## ON-SITE SEWAGE DISPOSAL SYSTEM HOWARD COUNTY HEALTH DEPARTMENT BUREAU OF ENVIRONMENTAL HEALTH

SUBDIVISION: Wildflower Woods LOT NUMBER: K

ADDRESS: 3301 Rosemary Lane Brian Pugh

TITLE: **WELL & SEPTIC PLANS WILDFLOWER WOODS LOT K**

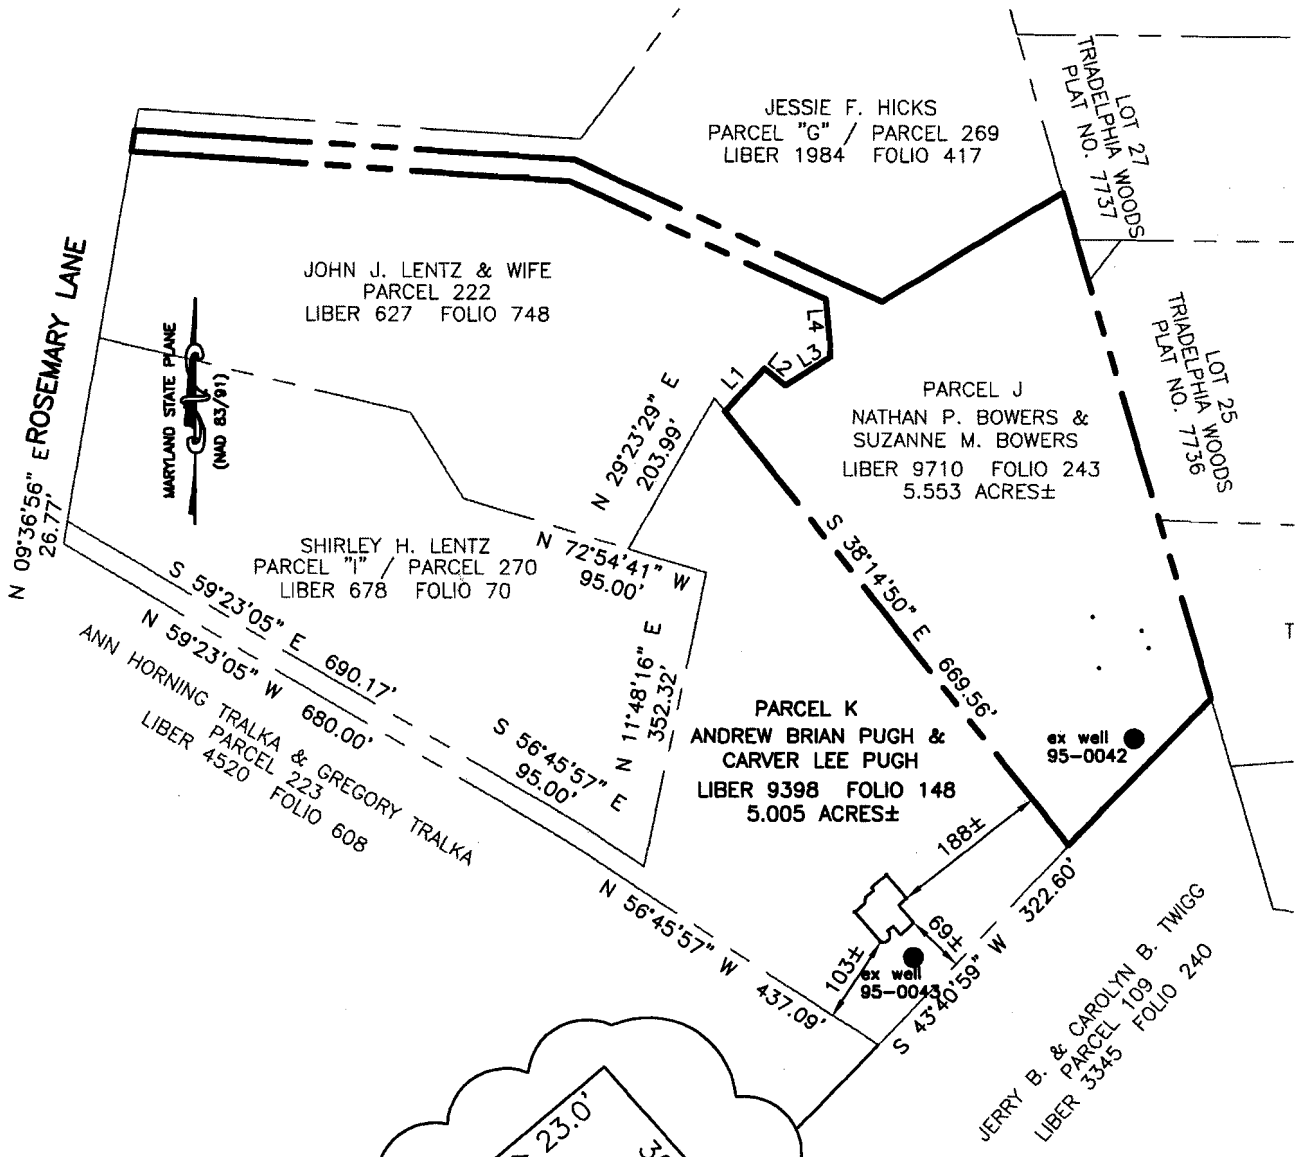
PRE-CONSTRUCTION 5/4/06 O.K. to install tank in location drawn on building permit plan. Make sure tank is 100' from well.

INSTALLATION Trench layout needs to be determined with a transit. Need to install one trench above large tree and one trench directly below it. (BB) 6/1/06 Tank set. Place the distribution box directly after the tank and install 2-75' trenches on contour across the easement. The top trench should be directly below the largest tree. (BB) 6/3/06 Trenches installed. Plumbing done. Need tank cleanouts and distribution box levelers. (BB) 6/8/06 Cleanouts on tank and levelers

installed per contractor (BB)

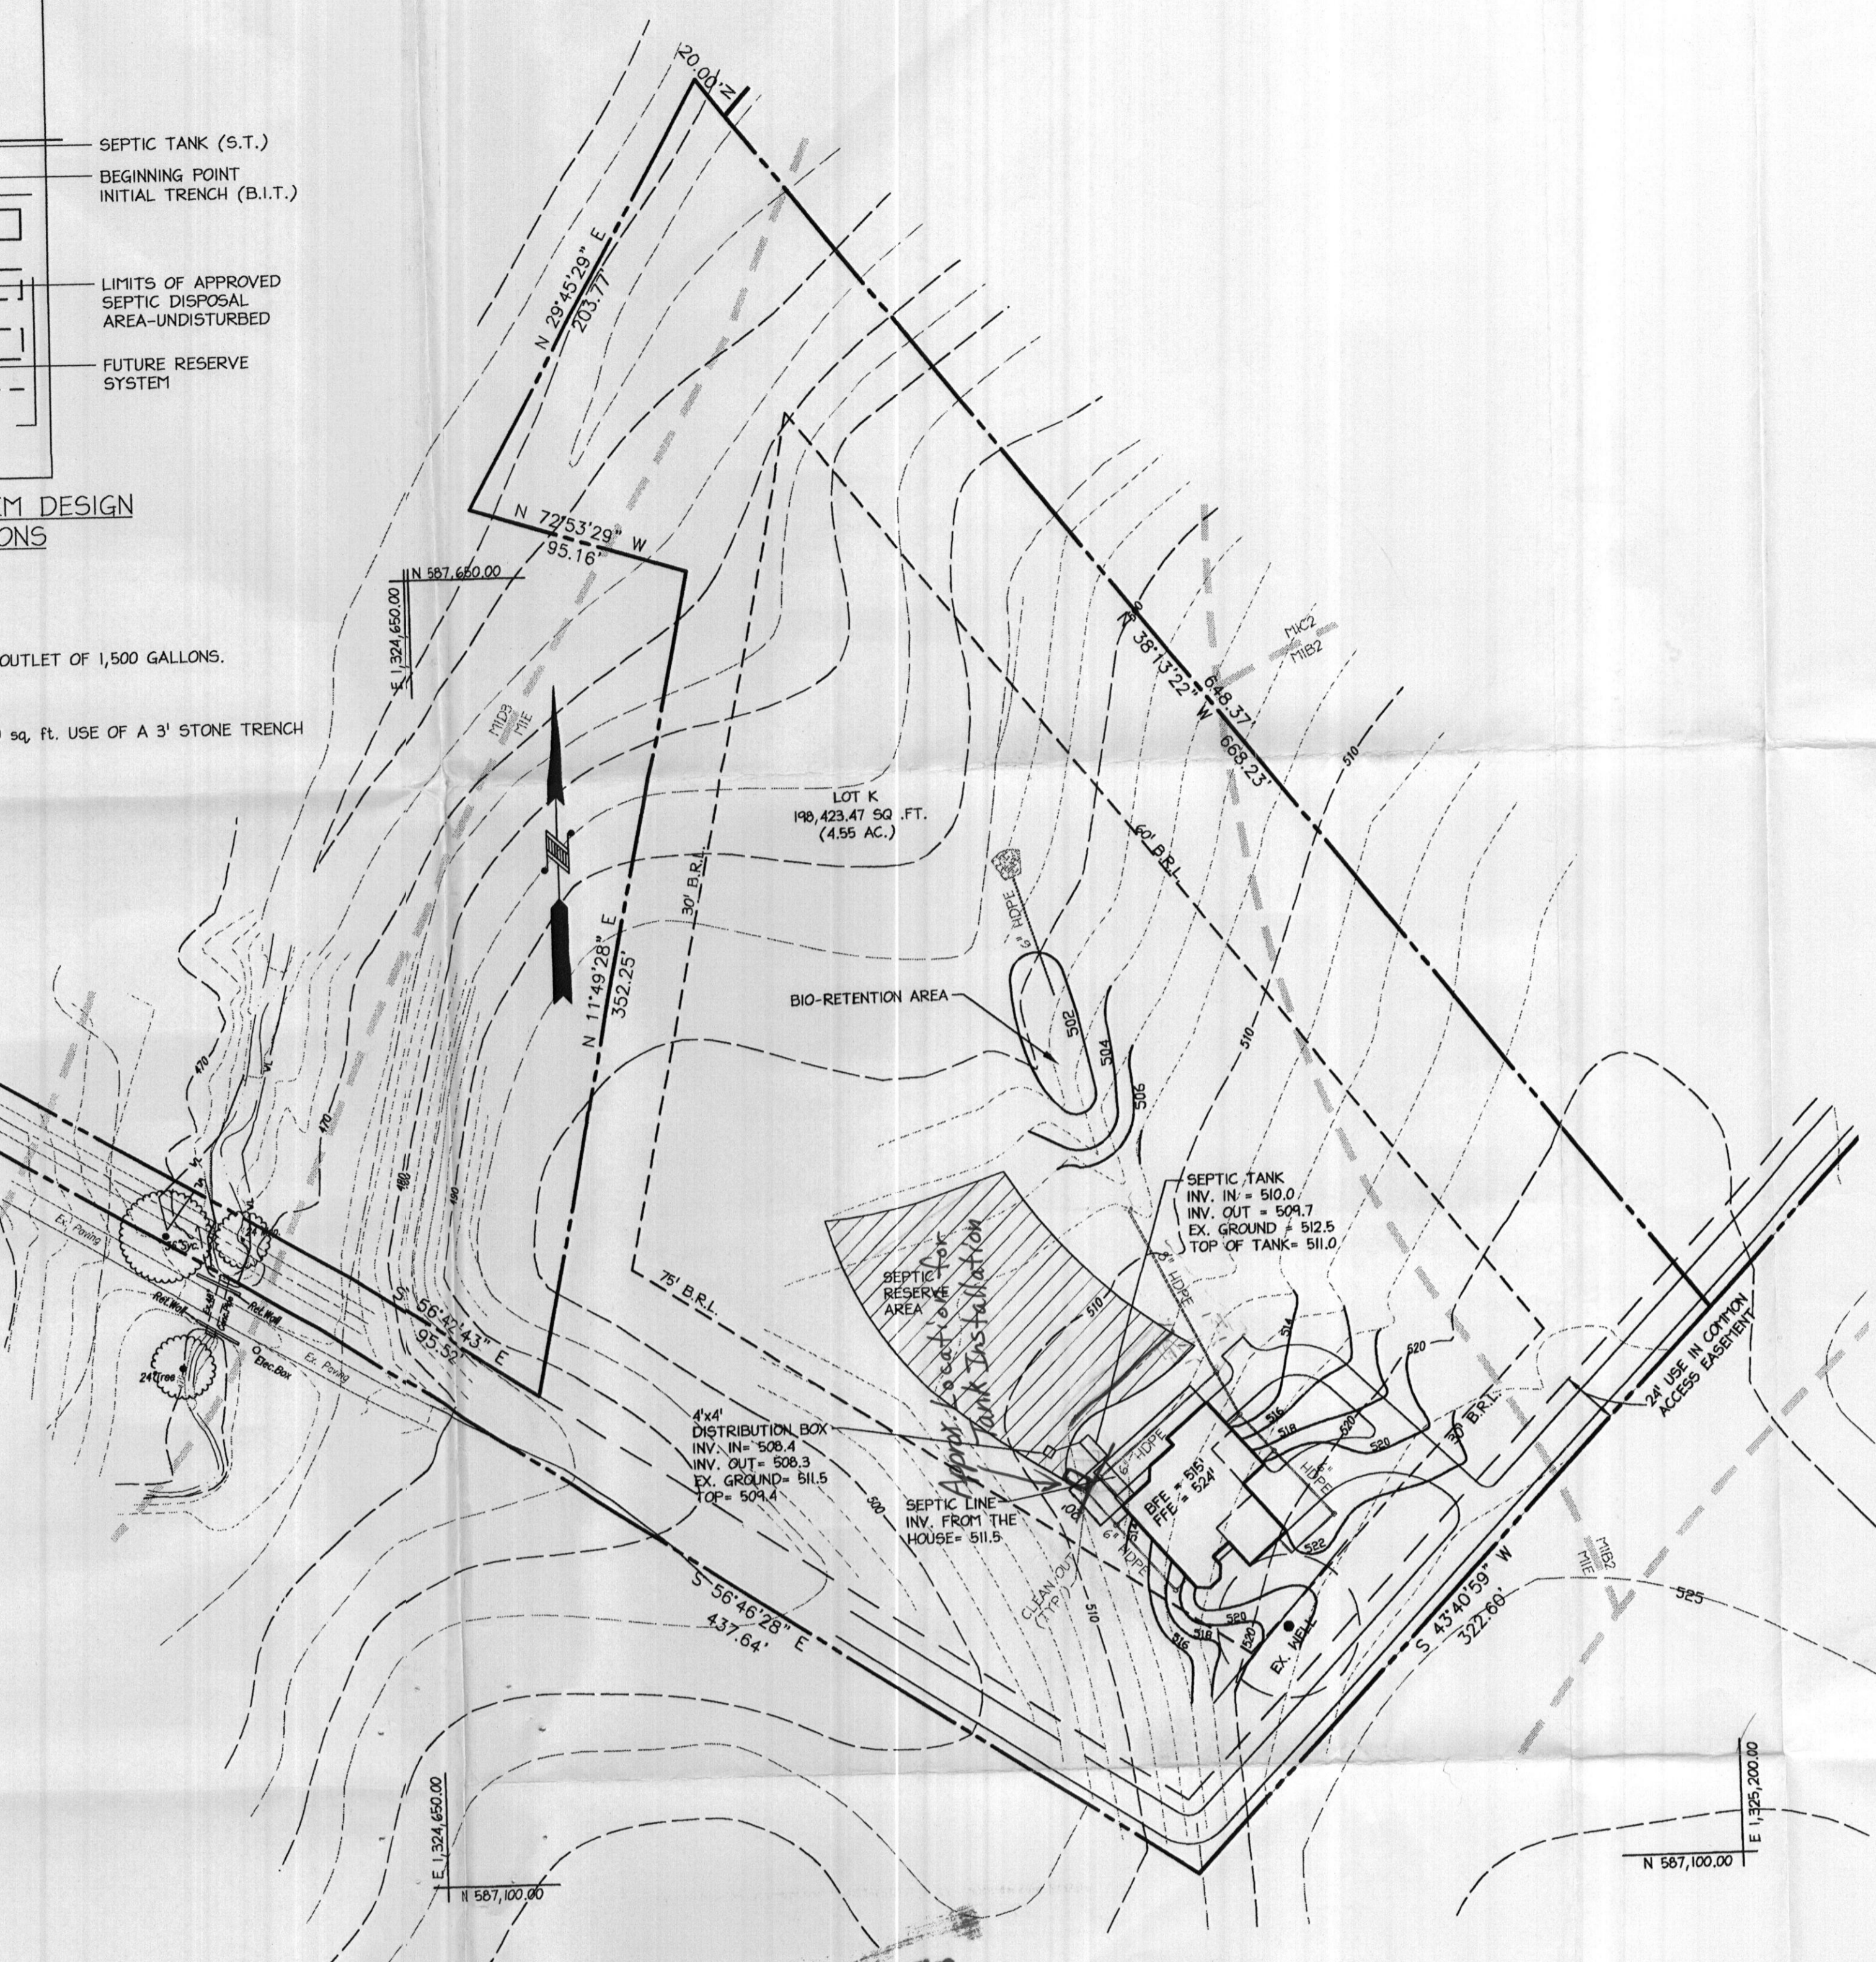
| TRENCHES: | Trench to be 3.0 feet wide. Inlet 3.0 feet below original grade. Bottom maximum depth 7.0 feet below original grade. Effective area begins at 3.0 feet below original grade. 4.0 feet of stone below distribution pipe. |
| LOCATION: | Keep distribution box at the highest elevation in the approved SDA.   |
